Reference: H02/0171/94

Description: Extension to existing restaurant

Location : Bridge Inn The Common
Crowland

PLANNING AMENDMENT

REVISION 1 4/1/94 - NEW FIRE ESCAPE ADDED
PROPOSED EXTENSION AT
THE BRIDGE INN,
CROWLAND
SCALE 1:50
DATE FEB 94

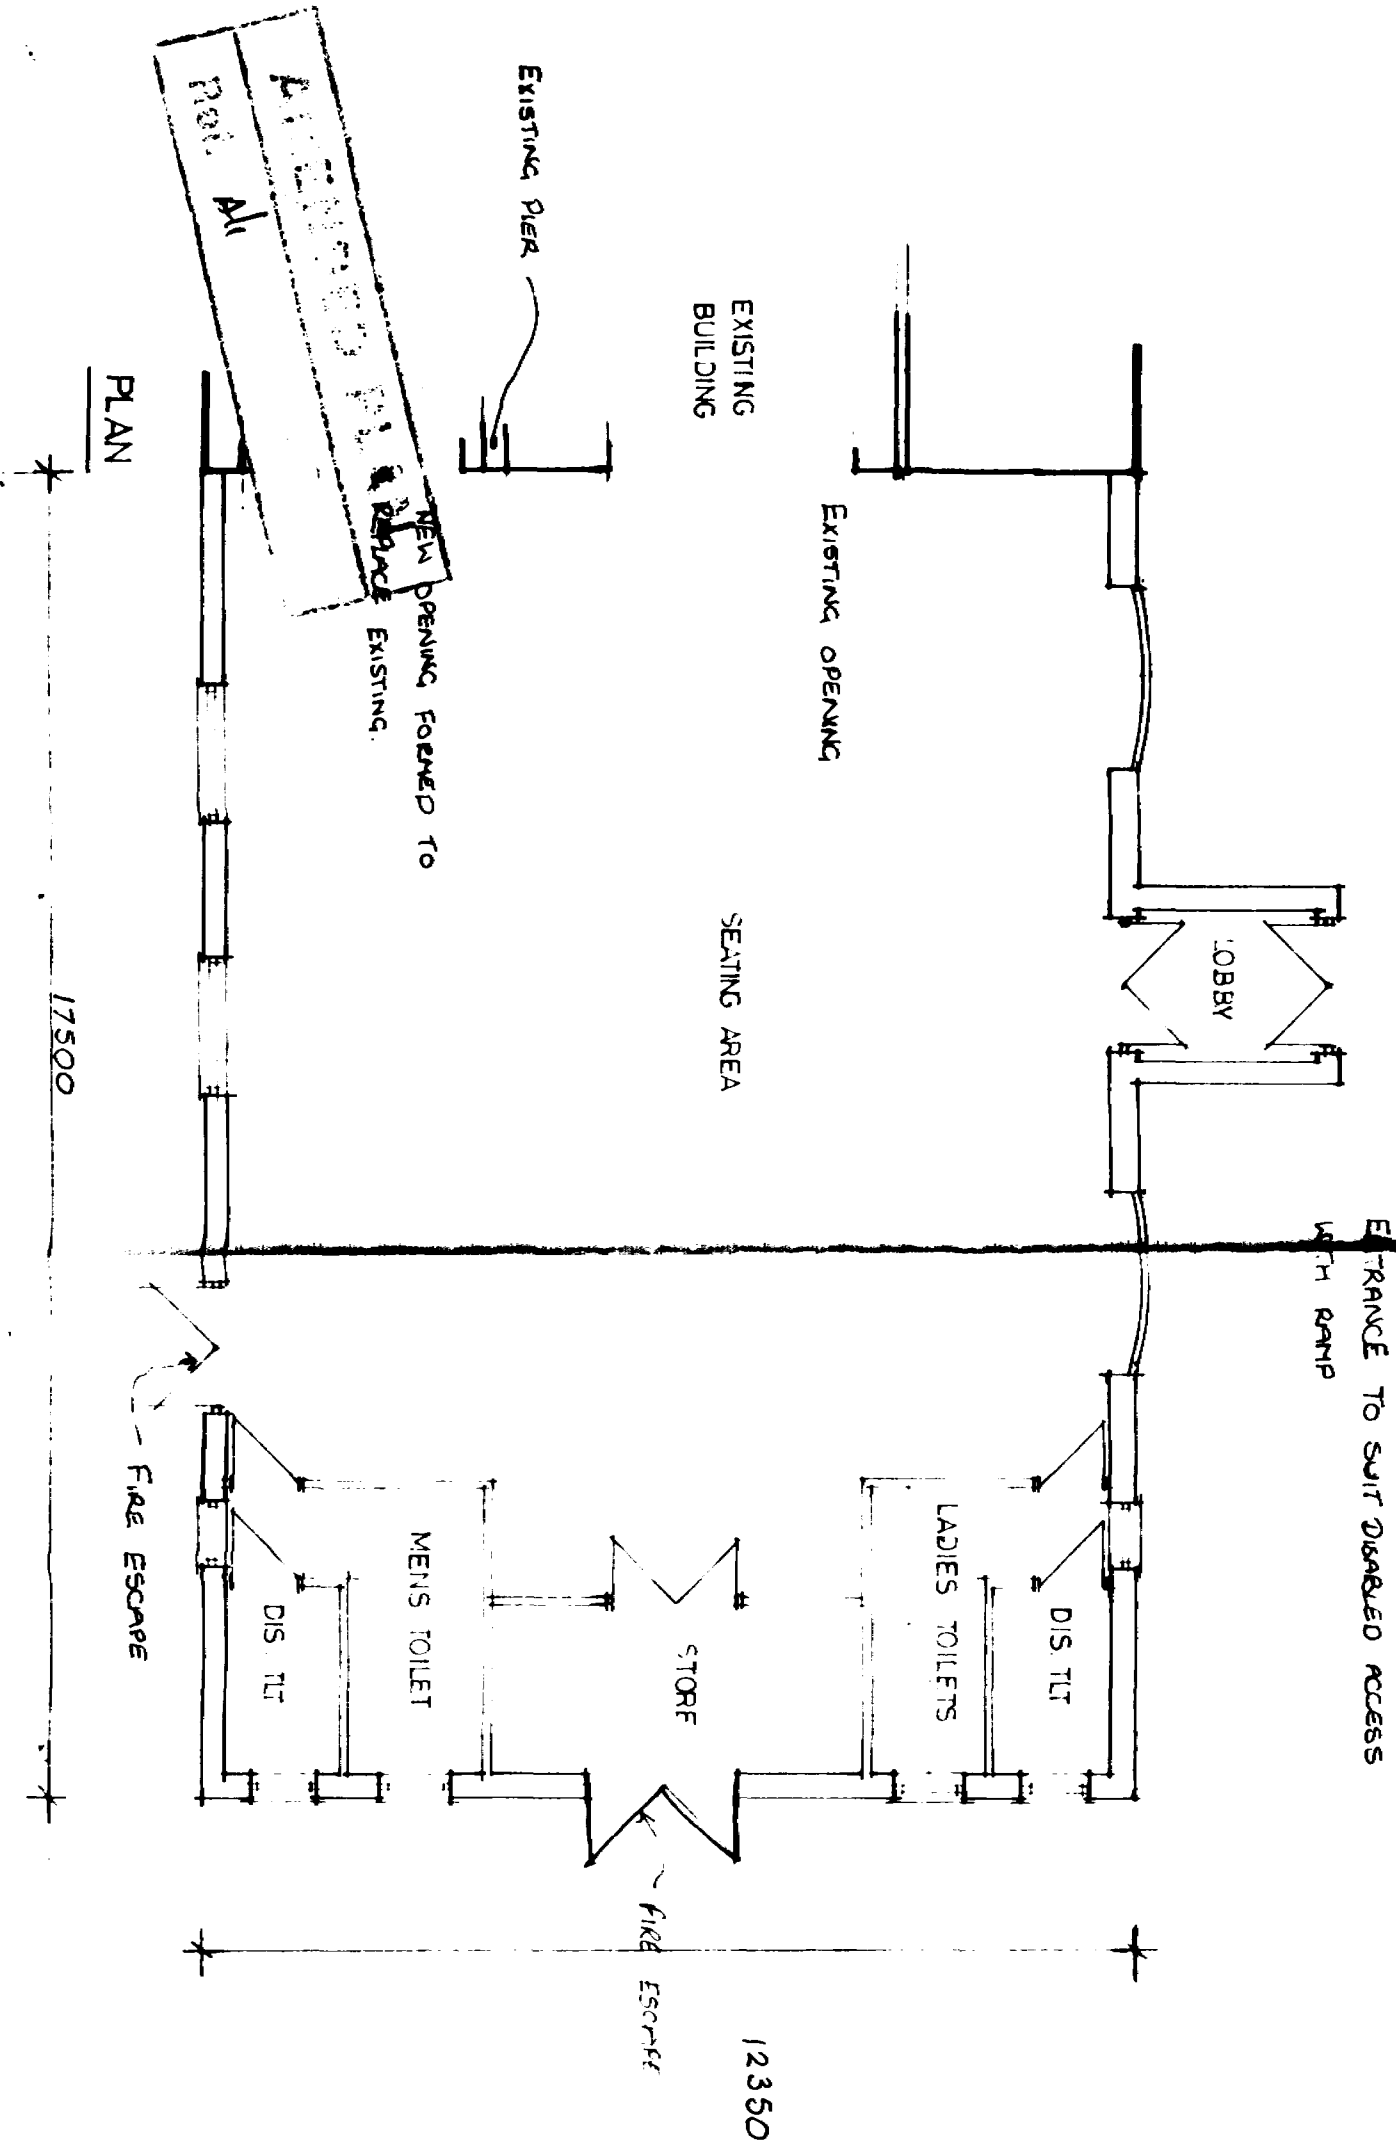
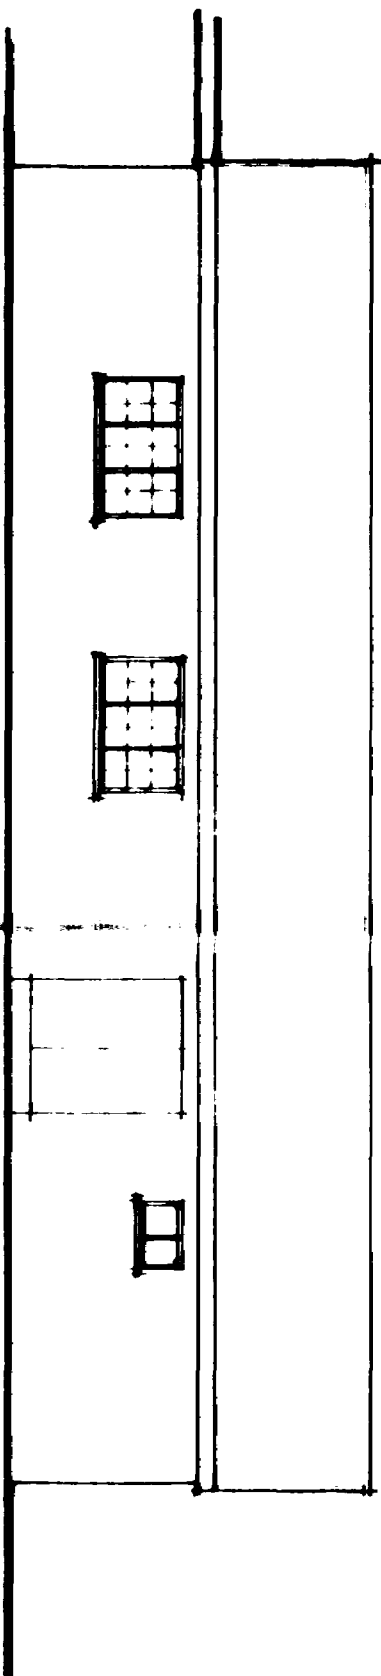
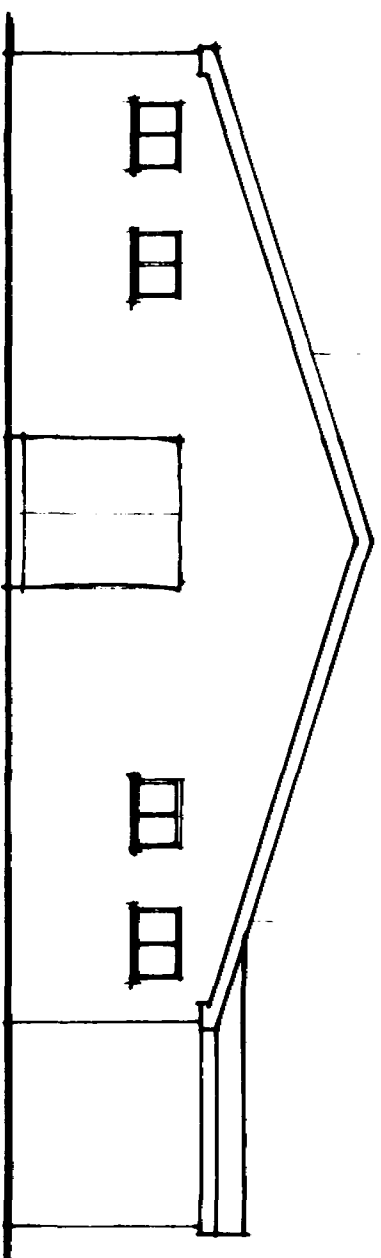
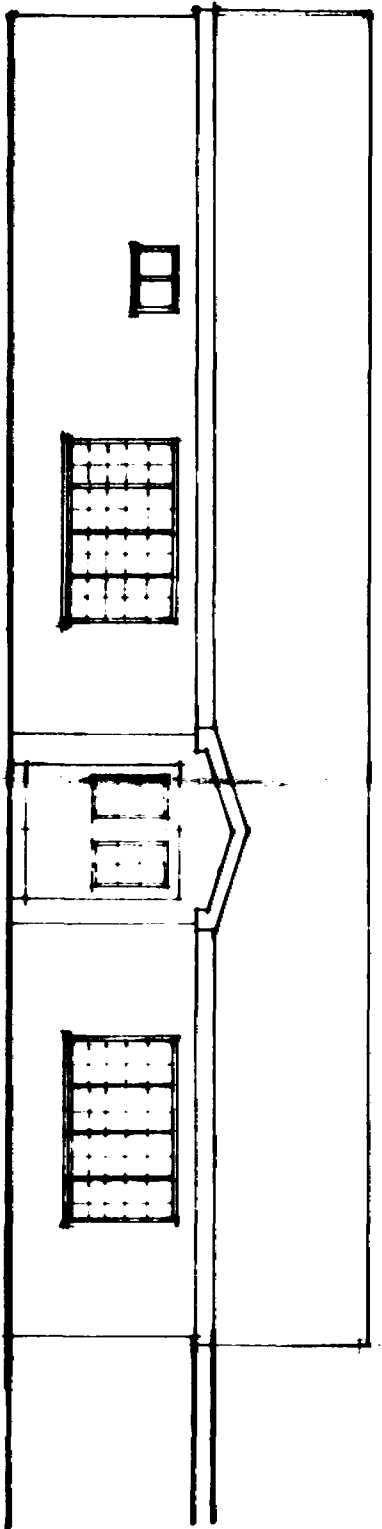
Amendment: New fire door added.

NEW FIRE DOOR ADDED

The amended details submitted in respect of the above proposal have now been considered, and I am able to inform you that there are no objections to the amendment being implemented to the extent described above.
